# Borough of Bay Head

## Zoning Permit

Block 5 Lot 12  
1606 Bay Avenue

Renovation of existing dwelling, proposed 12'x 20' pool, proposed paver patio and walkway, proposed 12'x 24' shed with groundwater recharge trenches.

**PROPOSED IMPROVEMENT PLAN**

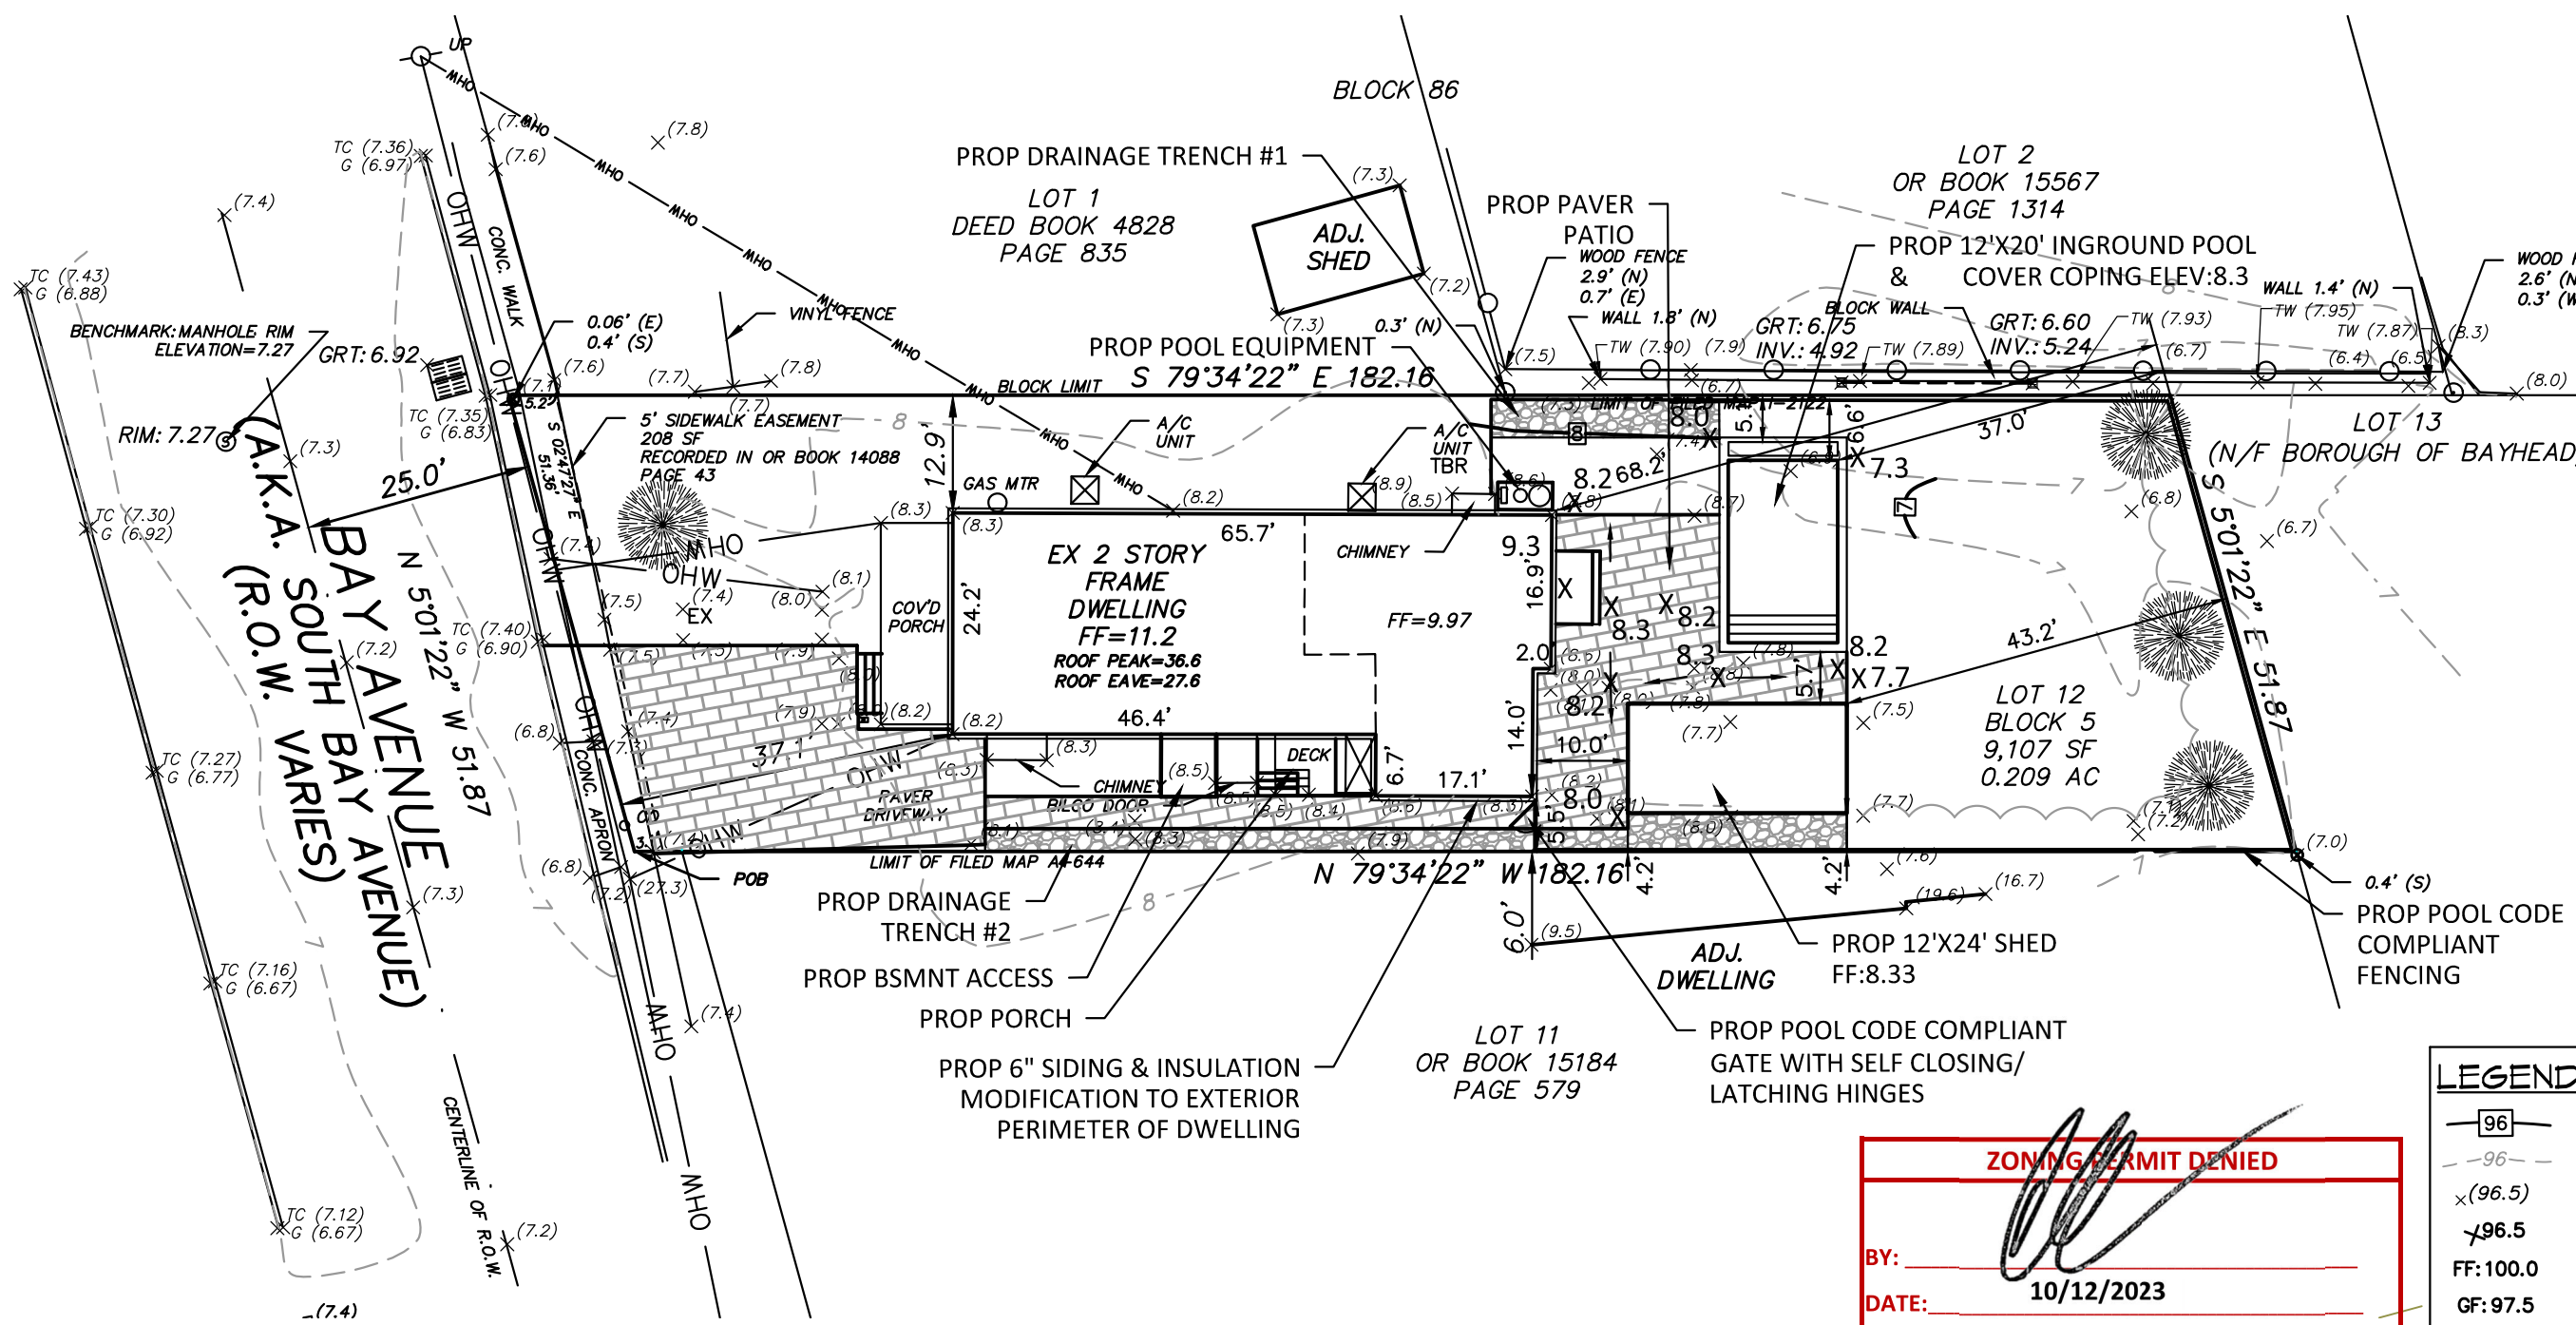
Proposed dwelling renovation reduces the south side yard setback from 6 feet to 5.5 feet which is nonconforming. Proposed walkway is nonconforming with minimum setback of 3 feet (south side). All remaining setbacks for dwelling and accessory structures are conforming. Proposed building coverage and lot coverages are conforming.

DENIED due to nonconforming side yard setbacks for dwelling and walkway (south side).

Applicant may submit conforming plan or seek approval of proposed nonconformities from Planning Board
